February 22, 2017

Southern Nuclear Operating Company
Vogtle Electric Generating Plant Units 3 and 4
Request for License Amendment and Exemption Regarding
Hydrogen Venting from Passive Core Cooling System (PXS) Compartments (LAR-17-003)

**Request for License Amendment Regarding
Hydrogen Venting from Passive Core Cooling System (PXS) Compartments
(LAR-17-003)**

Figure 3-1. Component Layout for Temperature Distribution

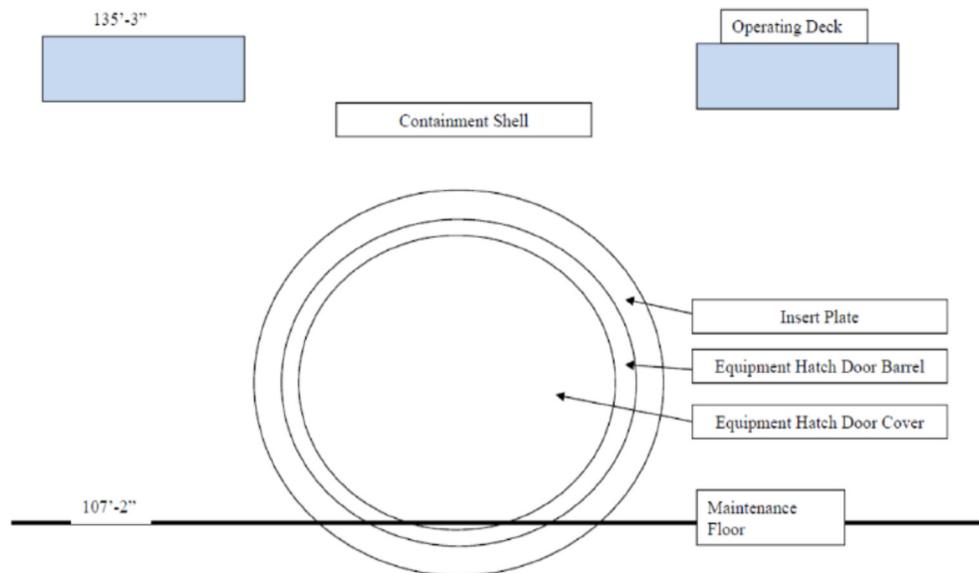
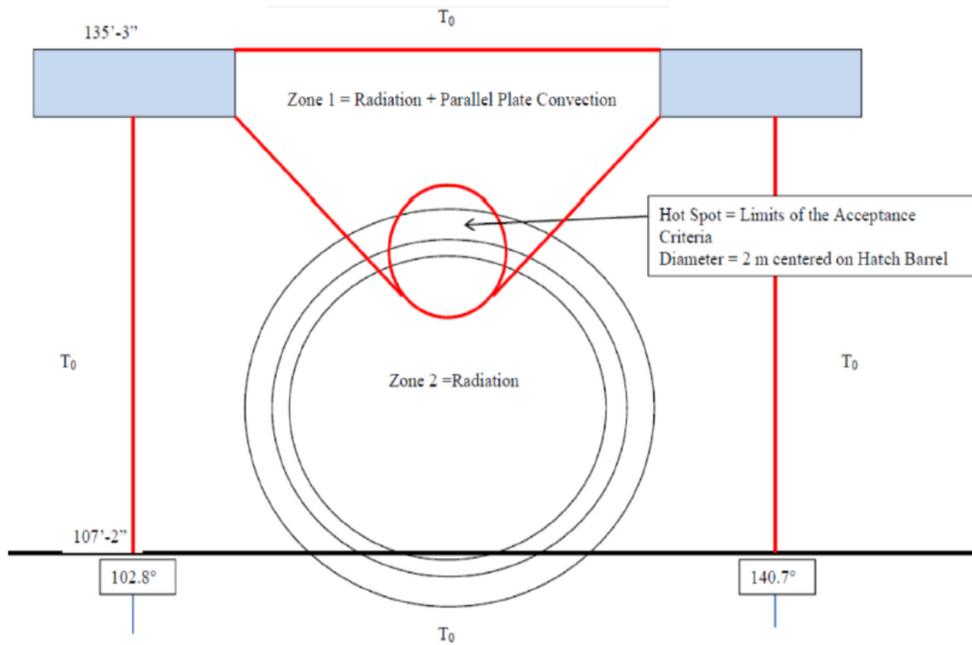
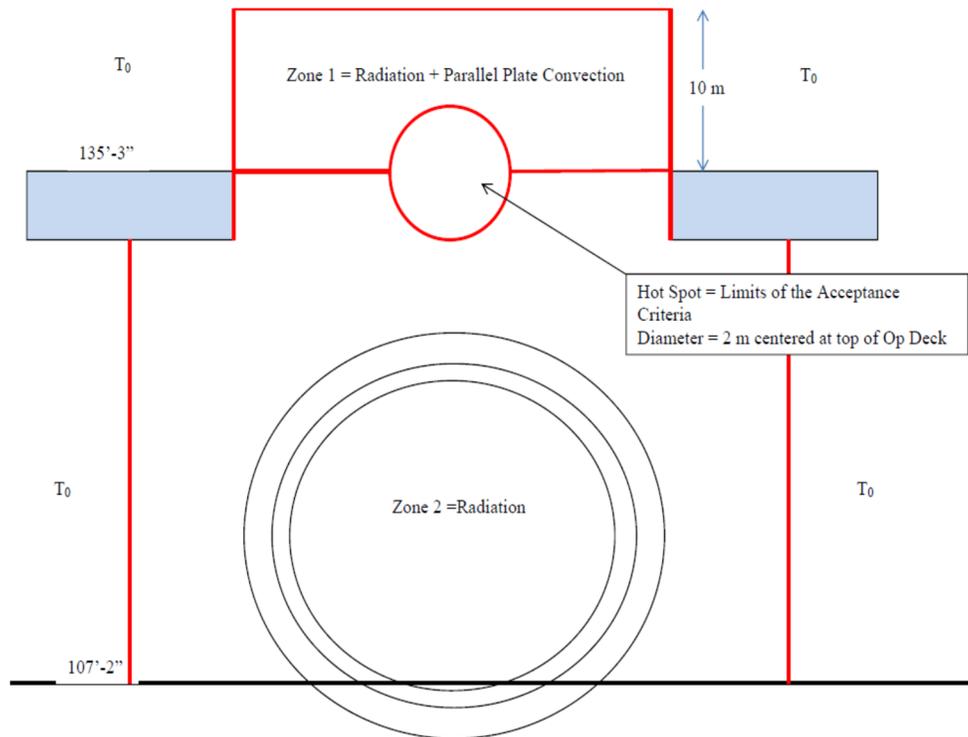
A one-dimensional heat transfer calculation was performed to evaluate temperature distribution on the containment vessel resulting from the diffusion flame hydrogen burn. A CFD analysis was also performed. Insights from the CFD analysis are only used if they point to a non-conservative assumption. Given the nature of the modelling, the flame can only be modelled at each vent location individually. The results of the one-dimensional calculation and the CFD model show the equipment access opening produces the highest temperature on the containment shell and equipment hatch. The analysis created two temperature distributions. The first distribution assumed that the plume creates a hot spot that spans the hatch cover, hatch barrel, insert plate and containment shell. The second distribution was developed based on the insights from the CFD analysis in which the hot spot occurs on the containment shell at the vent exit.

The hot spot is the local area where the burning plume flow impacts the containment pressure boundary. The heat transfer consists of radiation heat transfer and horizontal (flat plate in cross flow) and vertical (flat plate in parallel flow) convection. For the structural analysis, the surface temperatures within the hot spot are the bounding temperature limits of the containment shell and the hatch door cover. For the hatch barrel hot spot temperature, where the hatch seals are located, the average wall temperature was calculated and the corresponding surface temperature is reported. Zone 1 is the area of the containment pressure boundary above the hot spot in contact with the plume that flows up the containment wall. The heat transfer consists of radiation heat transfer and vertical (flat plate in parallel flow) convection. Zone 2 is the area of the containment pressure boundary below the hot spot where the containment shell is not in contact with the plume flow but is receiving radiation heat transfer from the plume. The resultant temperatures are shown in the table and figures below.

In order to assess the integrity of the containment vessel, these temperature profiles were used as inputs for structural analysis. The containment vessel and equipment hatch cover are SA738 Grade B steel. The hot spot area shown on Figure 3-2, above, is at the top of the equipment hatch and covers the hatch barrel. A finite element analysis was used to calculate the maximum resultant stress intensity corresponding to the hot spots on the equipment hatch. The maximum resultant stress intensity on the equipment hatch is 15.25 ksi which is below the ASME Service Level C limit of 63.6 ksi. Therefore, although at the hot spot the equipment hatch cover peak temperature (780°F) exceeds the maximum service level temperature (650°F), the maximum resultant stress intensity is less than the ASME Service Level C allowable limit and meets the Service Level C requirements of ASME Code, Section III, Division 1, and Subsection NE-3230.
